Addendum Number: 01

Addendum Issue Date: December 1, 2023

Project Name: Marshall Public Library Renovation

Project Number: 0230585.00

FIRST & SECOND FLOOR REFLECTED CEILING PLANS

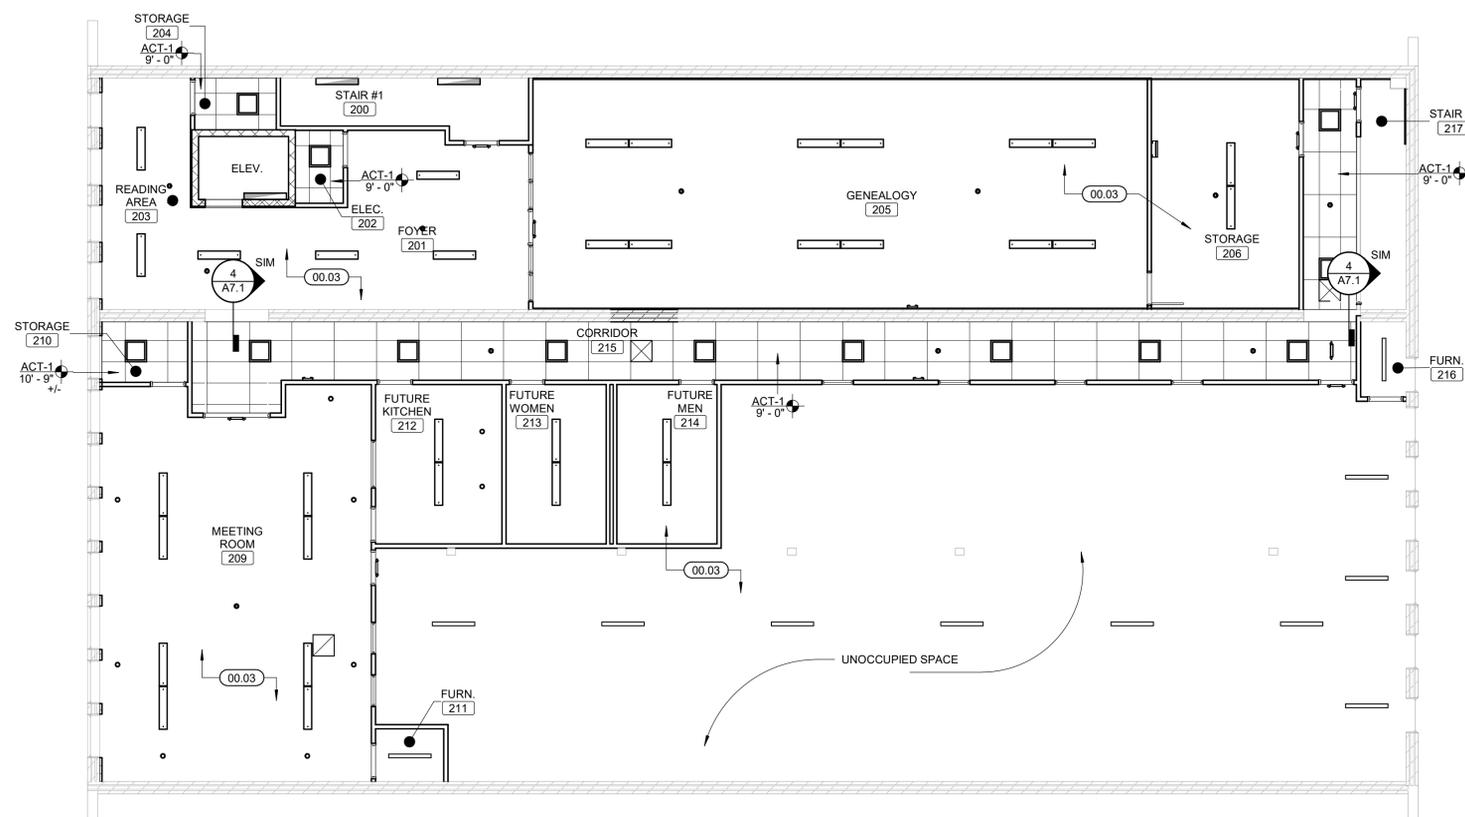
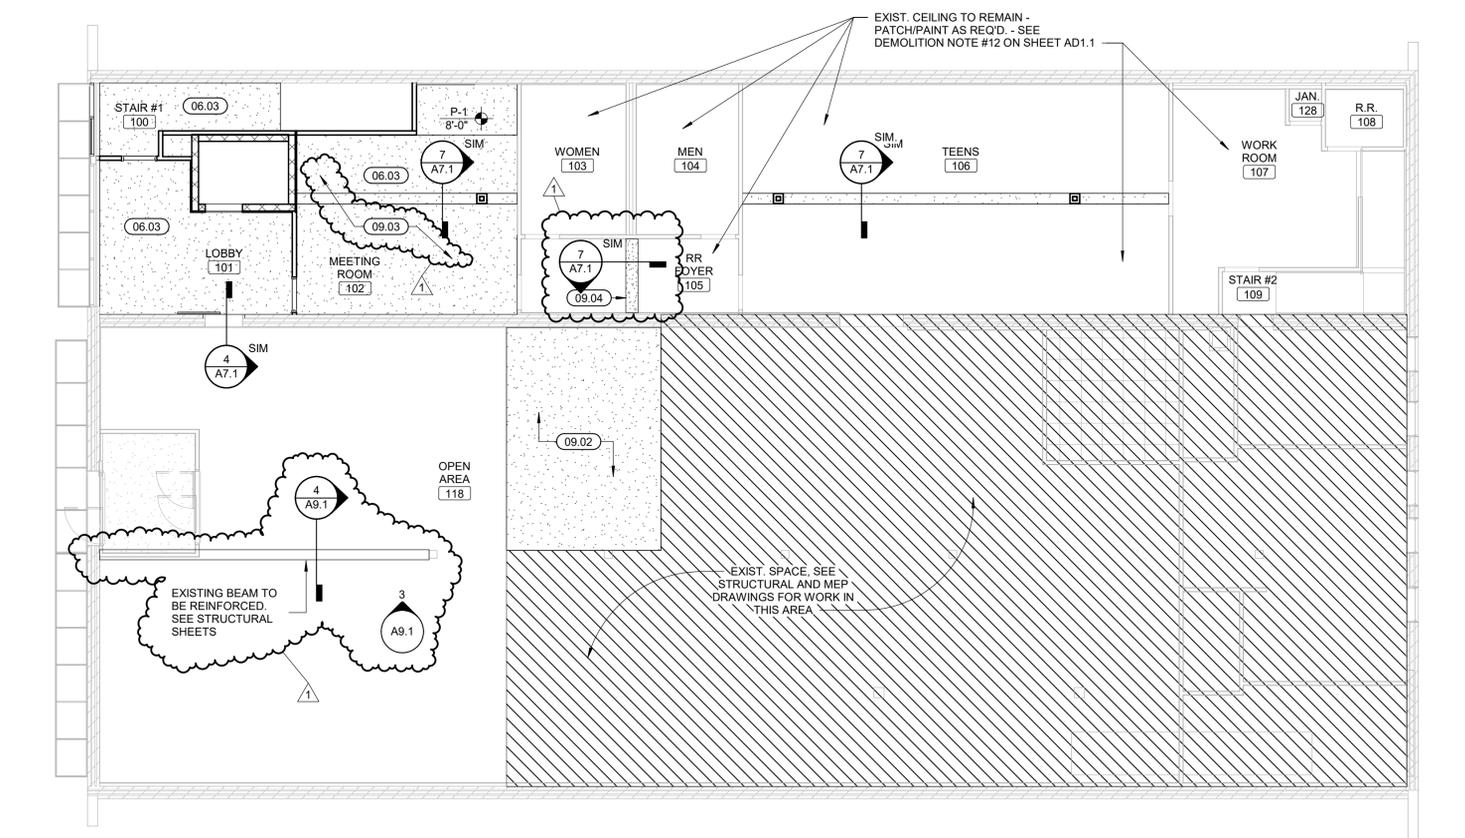
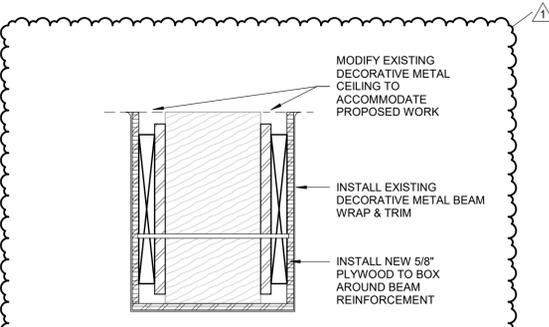
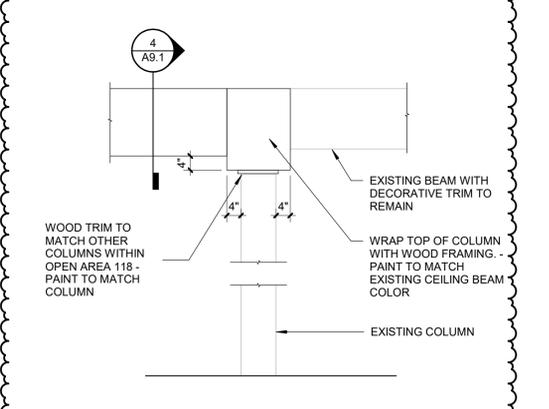
- c. Detail 8 – Rigid insulation has been added to the detail above the aluminum storefront.
 8. A9.1 – First & Second Floor Reflected Ceiling Plans
 - a. Modified keyed note '09.02'. The proposed soffit in Open Area 118 to conceal the plumbing piping shall be constructed utilizing 2x wood construction.

- b. Added keyed note '09.03'. Reinstall salvaged decorative metal ceiling in Meeting Room 102.
 - c. Added keyed note '09.04'. Install new bulkhead to conceal sanitary piping.

- d. Details have been added for the beam reinforcement work in Open Area 118.
 9. I0.1 – General Information
 - a. The soundproofing indicated on I1.1 in the General Notes shall be as per Kinetics IsoLaymentQT 5mm or approved equal.

SHEET TITLE:
ELECTRICAL DEMOLITION PLAN

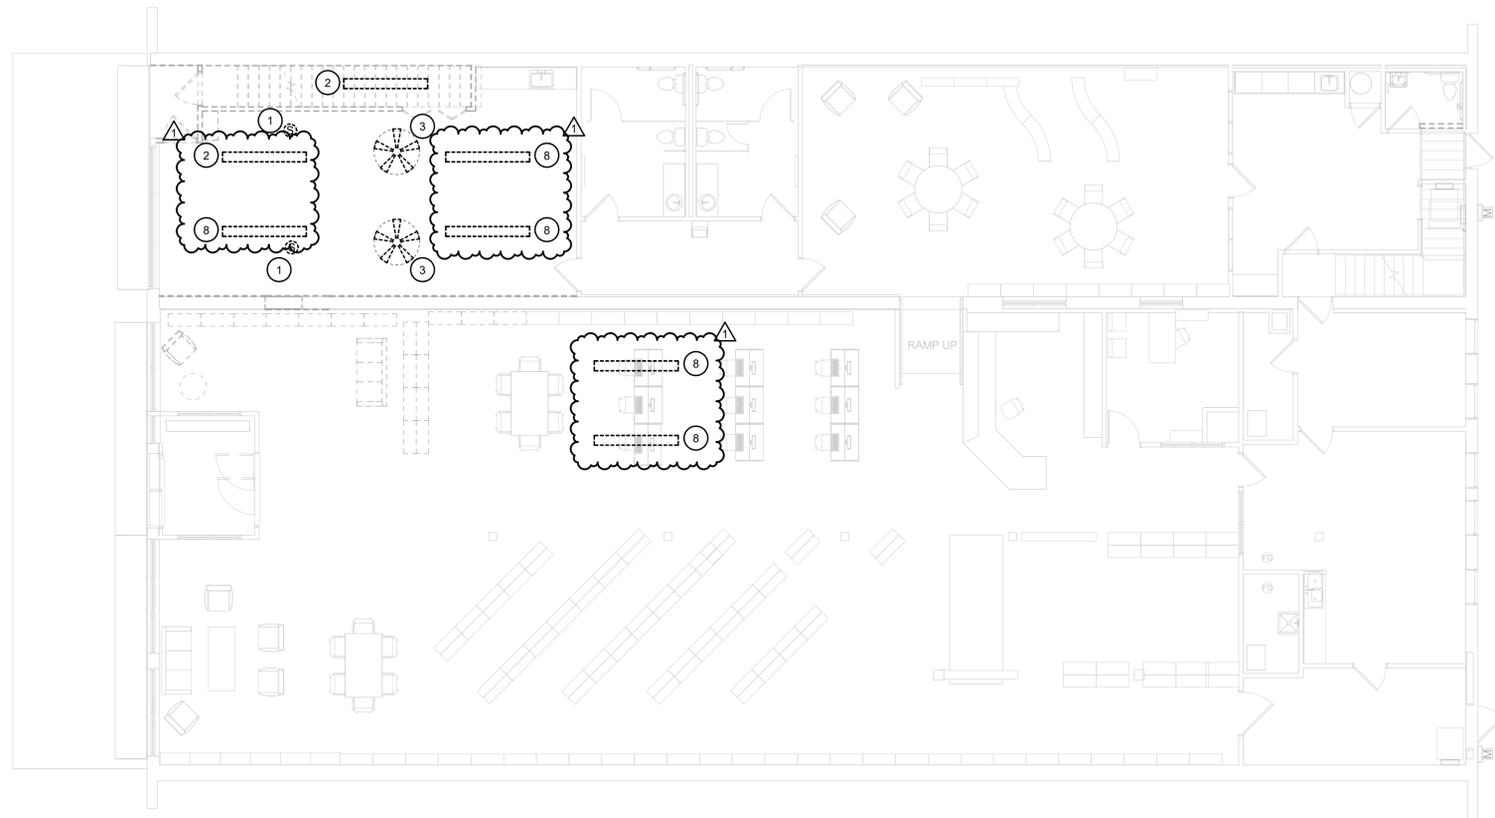
11. ED1.1-Electrical Demolition Plan
 - a. First Floor – Main Library side – existing light fixtures identified for removal and re-installation once second floor plumbing rough-in and ceiling work is completed.

- b. First Floor – Conference Room - existing light fixtures identified for removal and re-installation once ceiling work is completed.
- c. Second Floor unfinished side over Main Library, clarified relocation of conduits routed along flooring. Also noted all exposed network and video cabling relocation work will be accomplished by others.

FIRST FLOOR LIGHTING PLAN

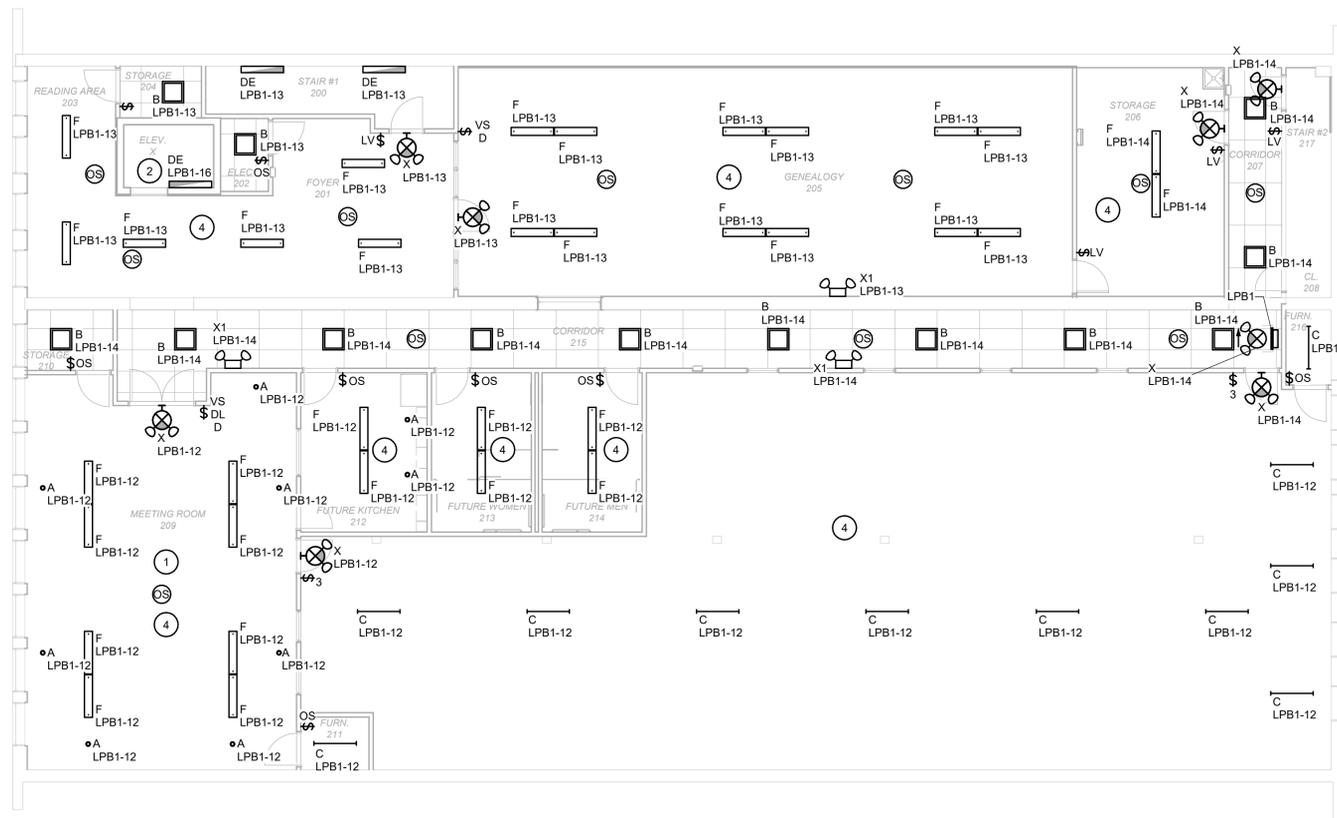
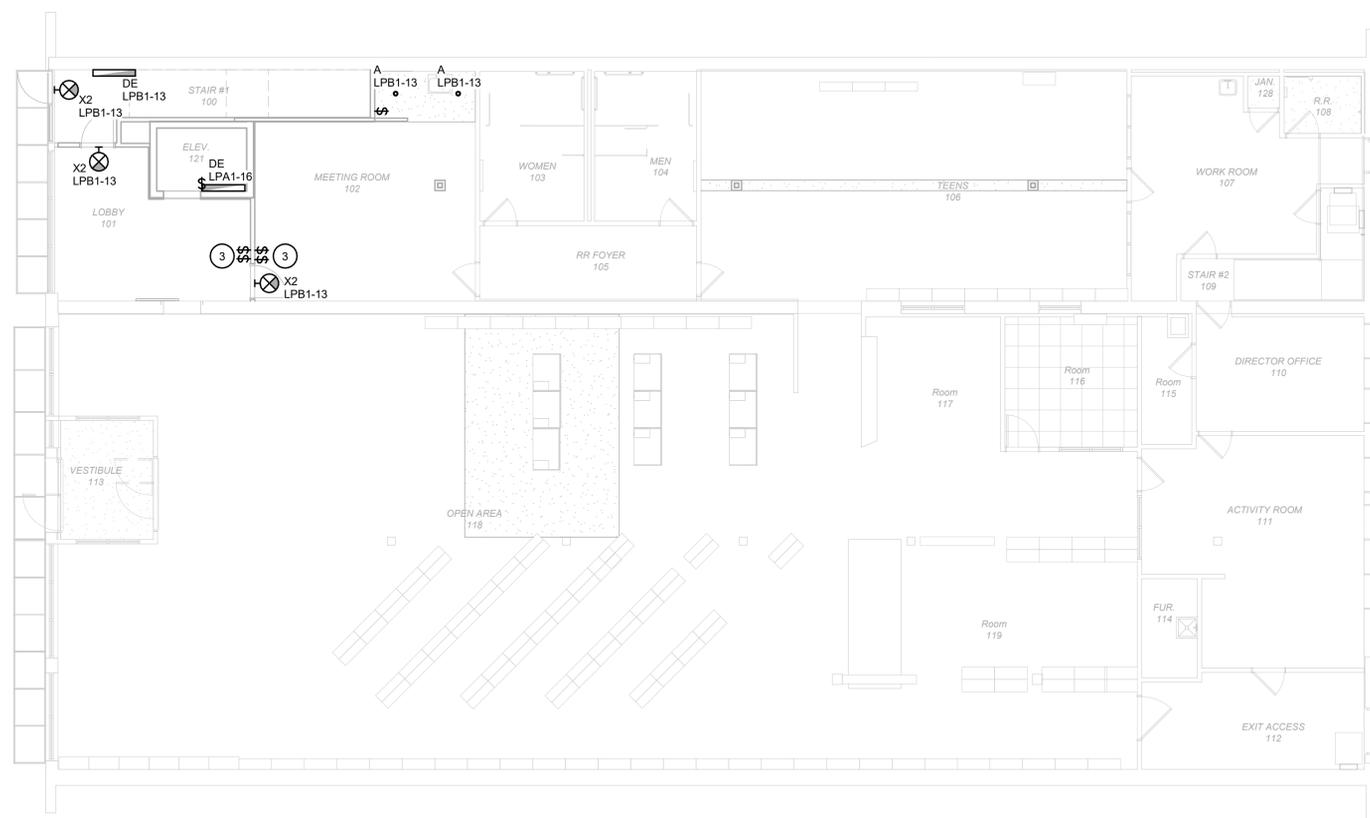
- a. Added General Note clarifying lighting fixture mounting in exposed ceiling areas of Second Floor.
- b. Added General Note clarifying conduit mounting and routing in exposed ceiling areas of Second Floor.

FIRST FLOOR SYSTEMS PLAN

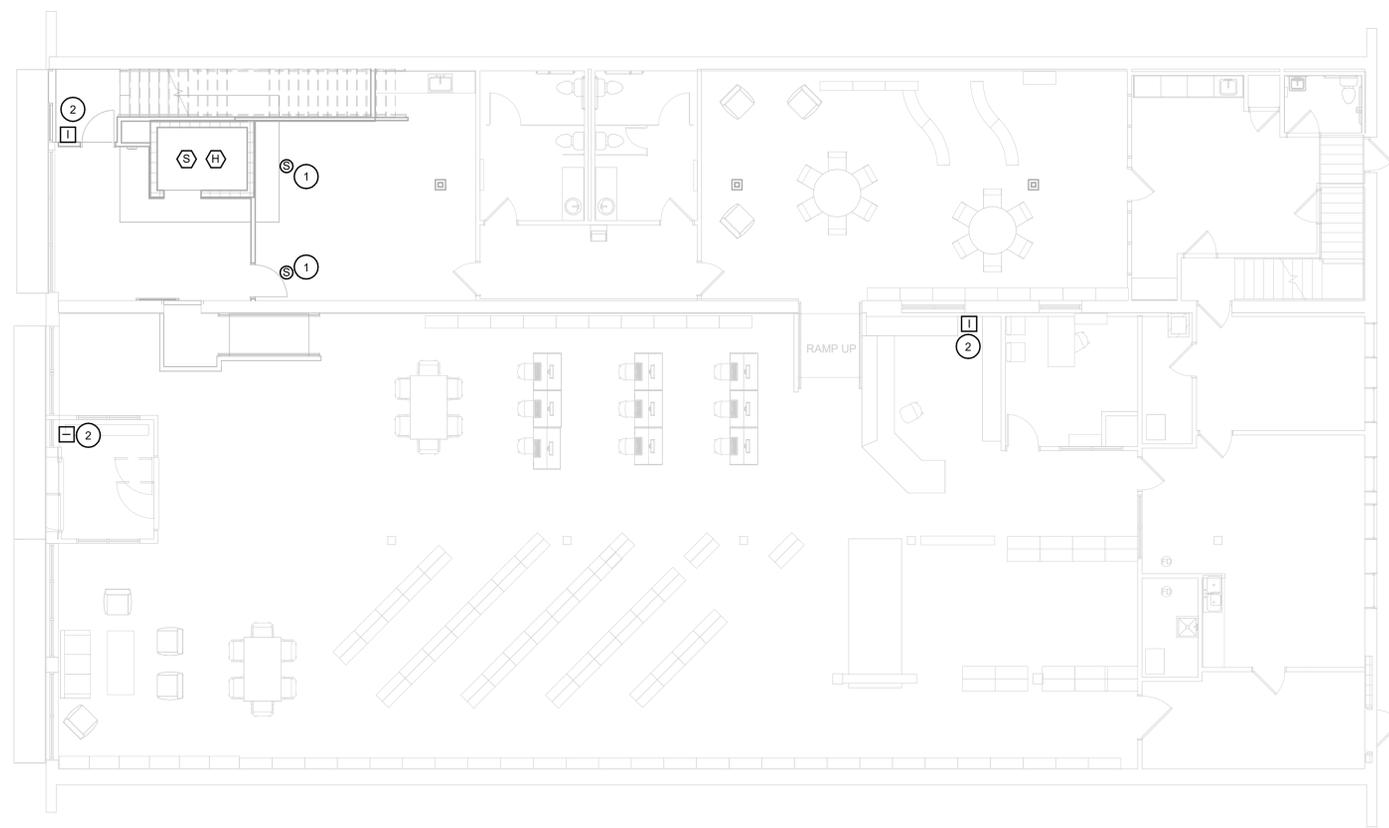
- a. Added General Note indicating all new network and video cabling work will be accomplished by others.
